CHART STANDARDIZATION & PAPER CHART WORKING GROUP (CSPCWG)

CSPCWG Letter: 07/2011

Subject: Actions arising from 7th CSPCWG meeting (Group 2)

This letter covers actions 9, 10, 12, 13, 16, 18, 19 and 23. Each is the subject of a separate Annex. In each case, the relevant extract from the Record of CSPCWG7 meeting heads the Annex, and is followed by the proposed new or revised text or other actions.

Example:

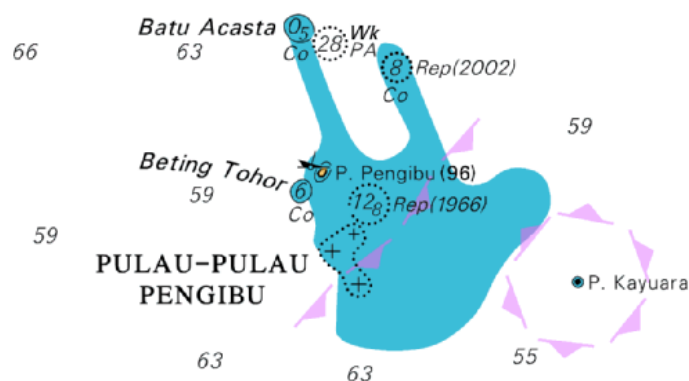
B-424.7 Imprecise Shoal Areas. It is important to depict known or suspected shoal areas on charts, so that the prudent mariner can avoid them, even where the actual depths cannot be shown because of the limitations of the source data. In areas where reliable hydrographic survey data is very limited or non-existent, it is sometimes possible to identify the existence of shoal patches by satellite imagery. Such areas should be charted by an area of full shallow water blue tint, without limiting line or contour. This is to avoid implying that the full extent or depth of the shoal has been established and also avoid conflicting line styles with any charted shoals from other sources that may lie close to or within the area.

An explanatory note should be included on the chart, eg:

SHOAL AREAS

The shoal areas depicted within the area of this chart without contours, thus: , have been derived from satellite imagery. Uncharted dangers may exist.
